OBJECTION TO PLANNING APPLICATION REF: DC/25/1364

Land at Staalcot Farm, Stalhouse Lane, North Heath, RH20 2HR

**Objection to planning application DC/24/0356
Land at Staalcot Farm, Stallhouse Lane, North Heath, RH20 2HR**

Flood Risk and Drainage Statement

Figure 9: Horsham District Council: Impact Risk Zones Map with relevant red zone the Site is located within outlined in black

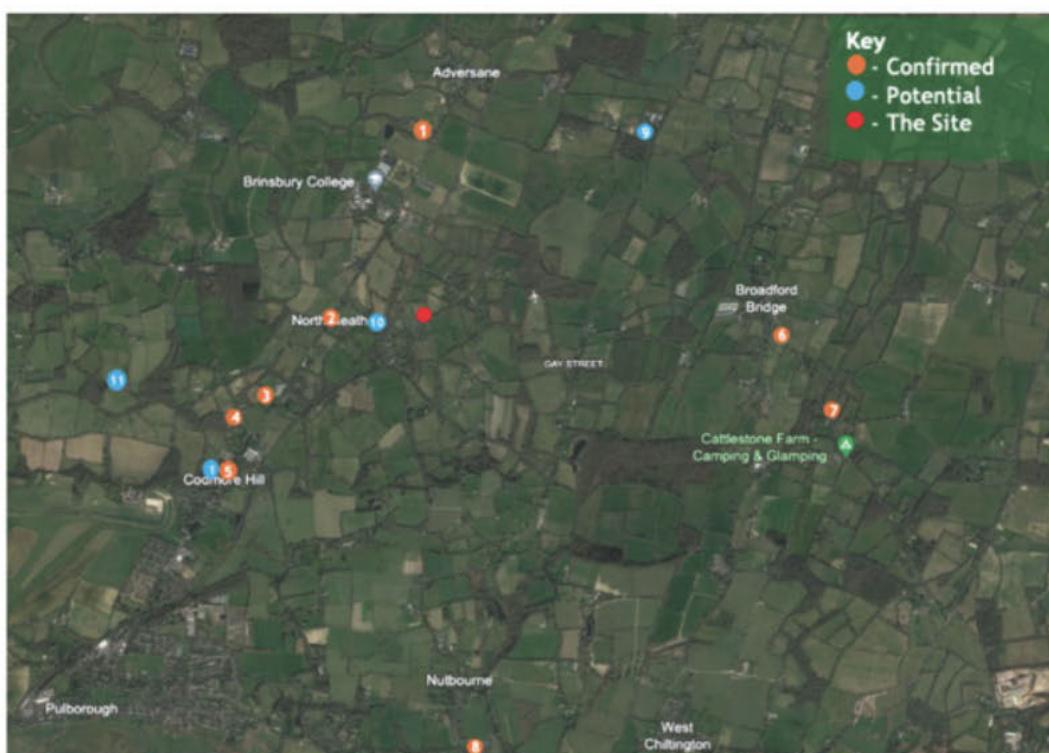
The PEA, which originally supported the planning application, does not reference the application Site being located within a red risk zone, which is of significant concern as GCN and their habitats are protected under the Conservation of Habitats and Species Regulations 2017 (as amended), the Natural Environment and Rural Communities Act 2006 (as amended) (NERCA) and the Wildlife and Countryside Act 1981 (as amended). All native reptiles are listed as rare and most threatened species under Section 41 of the NERCA.

The high risk location requires specific GCN surveys to be undertaken, which have not been actioned or recommended in the PEA. The proposed development does not adequately demonstrate the effect on protected species and the absence of such protection measures is a criminal offence. This is contrary to Local Policy 31 “Green Infrastructure and Biodiversity, which requires appropriate mitigation and compensation for adverse impacts on biodiversity. It should be noted that clearance of potential habitat has already taken place, so it is likely that an offence has already occurred.

Figure 1 Local Facilities Map

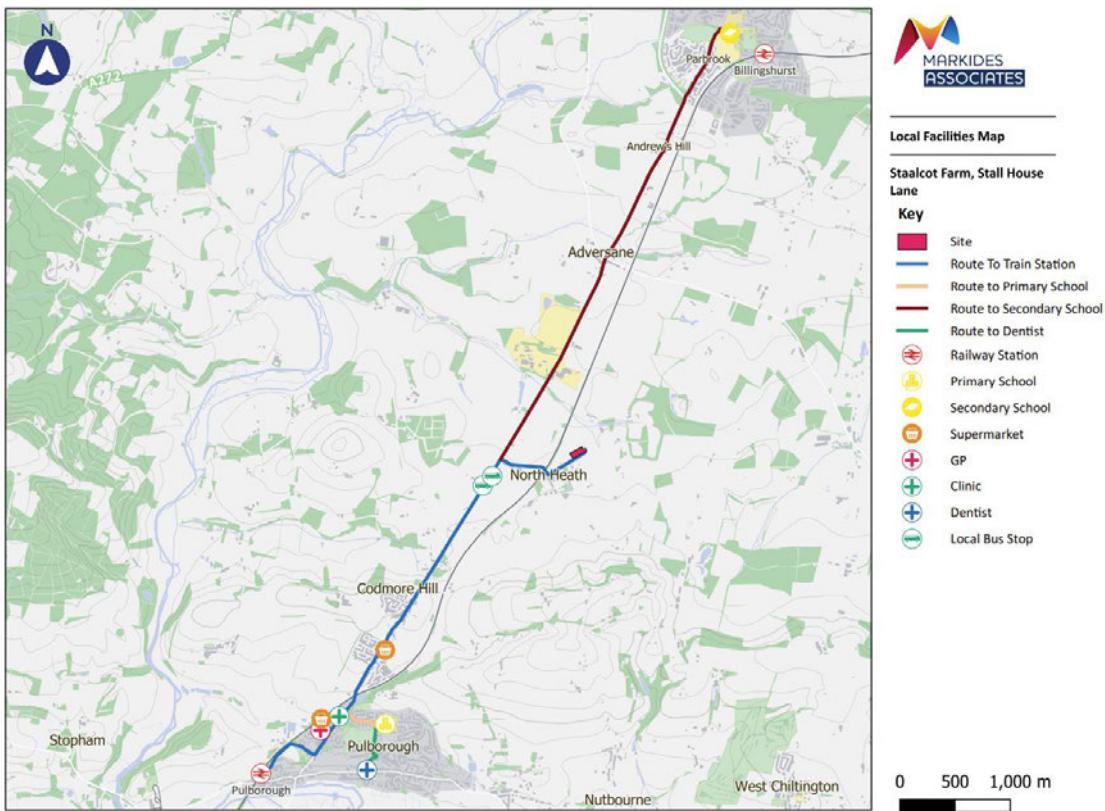
Based on the walk distance and average walk time in **Table 2**, it can be seen that the site is located well beyond the recommended acceptable walk distance to a range of local services and community facilities, in particular schools and essential health services as well as the nearest bus and train station.

The site cannot therefore be determined as being appropriately accessible with almost all facilities located well beyond the Acceptable recommended walking distances and the majority far beyond the Maximum recommended walking distances. As a result, the sites suitability for development, regardless of the number of trips that would be generated, is considered highly likely to result in a significant Car Driver and Car Passenger mode share and cannot be considered to be providing development in an area that is readily accessible to a range of transport modes. Accordingly, the proposed development is considered to not be complaint with:

Figure 1.1 Site Location Plan

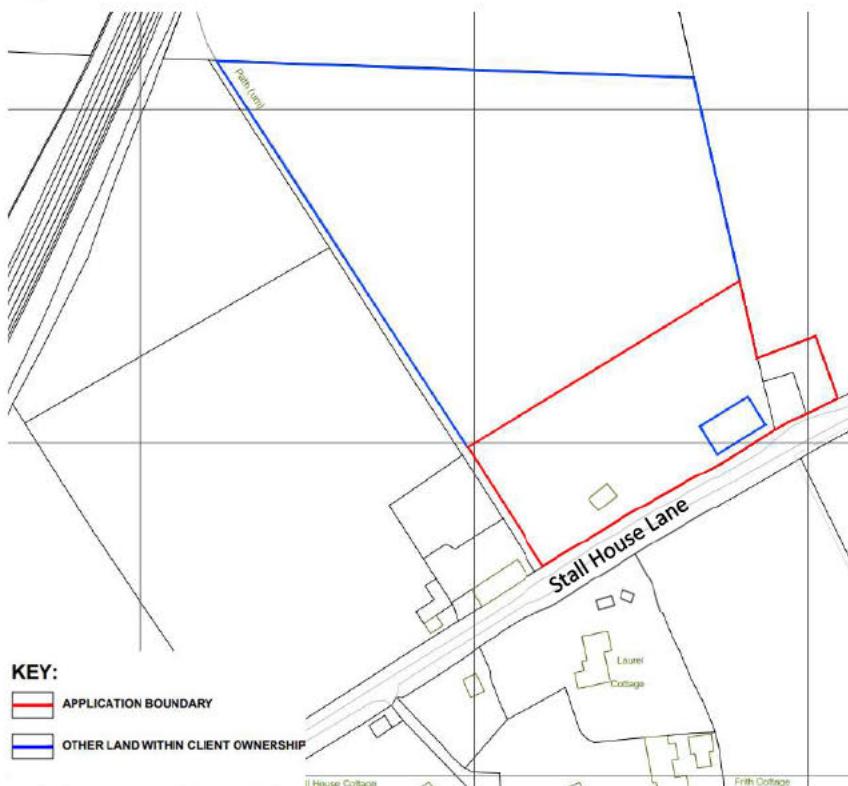
1.2.3 The site location is indicated in Figure 1.1 below, which highlights its position in relation to Stall House Lane.

Figure 3.3 Groundwater Vulnerability Map

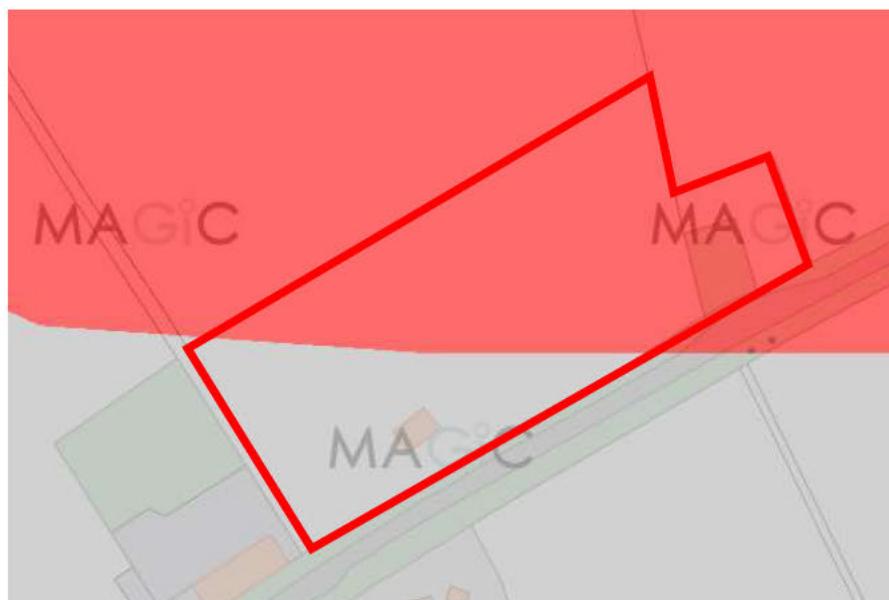
3.1.7 Should infiltration be found to be feasible, the northern part of the site is within an area with high groundwater vulnerability and shown in Figure X below, and therefore discharge to the ground may be subject to receiving the relevant permits from the Environment Agency (EA). It will be necessary to prove that the discharge will not pose a risk to groundwater quality and that appropriate treatment and pollution mitigation measures are in place, including the use of SuDS, which is also a requirement under SP38. Refer to Section 5 for more information on groundwater vulnerability.

5.1.1 As noted in Section 3, part of the site is located in an area with high groundwater vulnerability. The discharge of effluent from a package treatment plant in areas of high groundwater vulnerability presents a considerable concern due to the potential risks of groundwater contamination and adverse effects on water quality. In areas with high groundwater vulnerability the groundwater is often shallow, unprotected, or highly susceptible to surface water influence, increasing the likelihood of pollutants such as nitrates, phosphates, and microbiological contaminants entering the groundwater system.
